ADDENDUM NO. 1

Date: February 17, 2017

Project: E-Rate 20, Network Upgrade

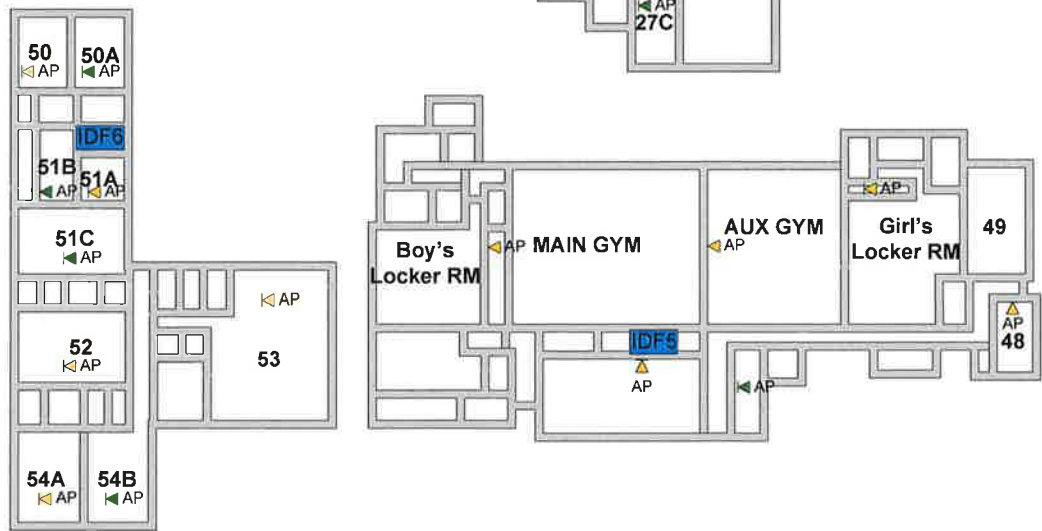
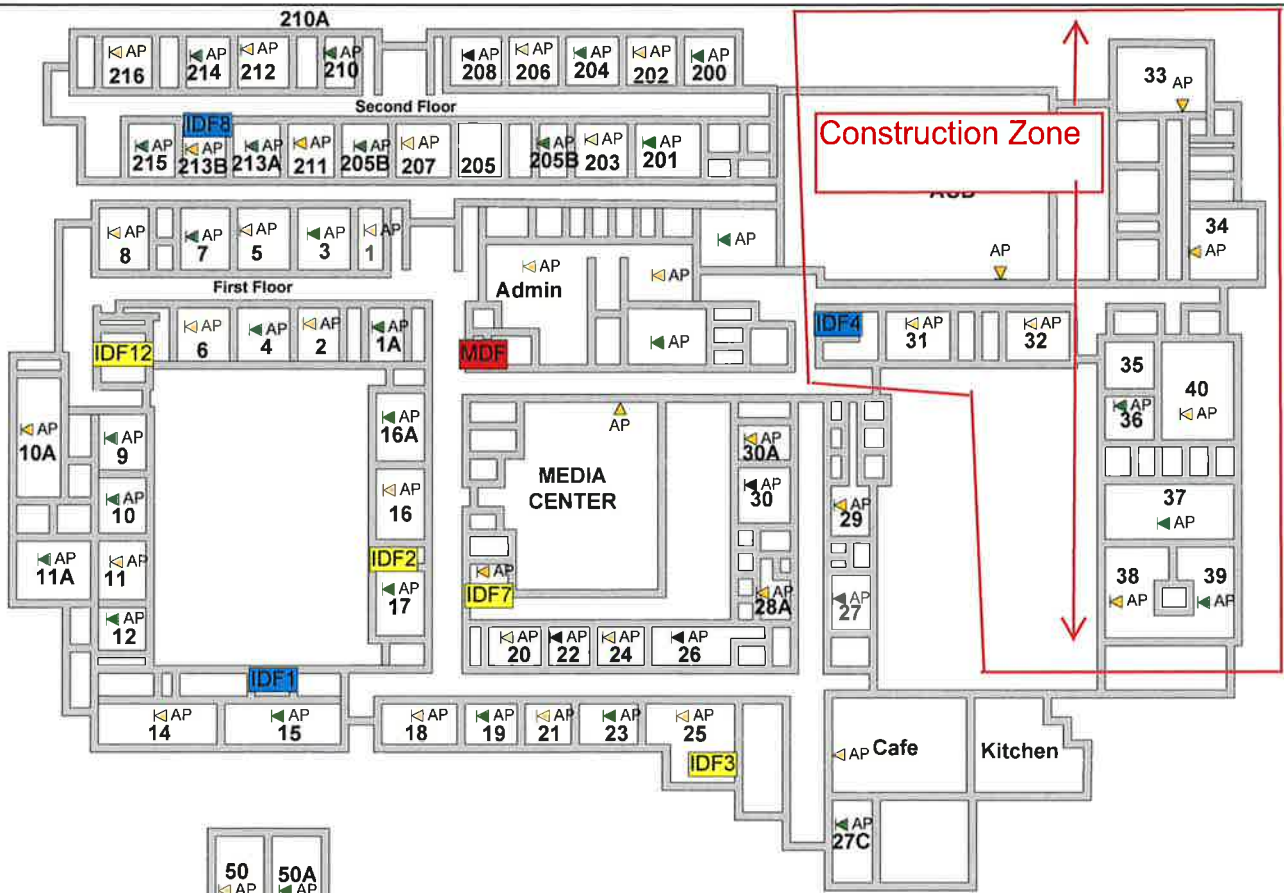
- 1.5.11 McClatchy scope of work does not include existing construction zone area. See added map for reference.
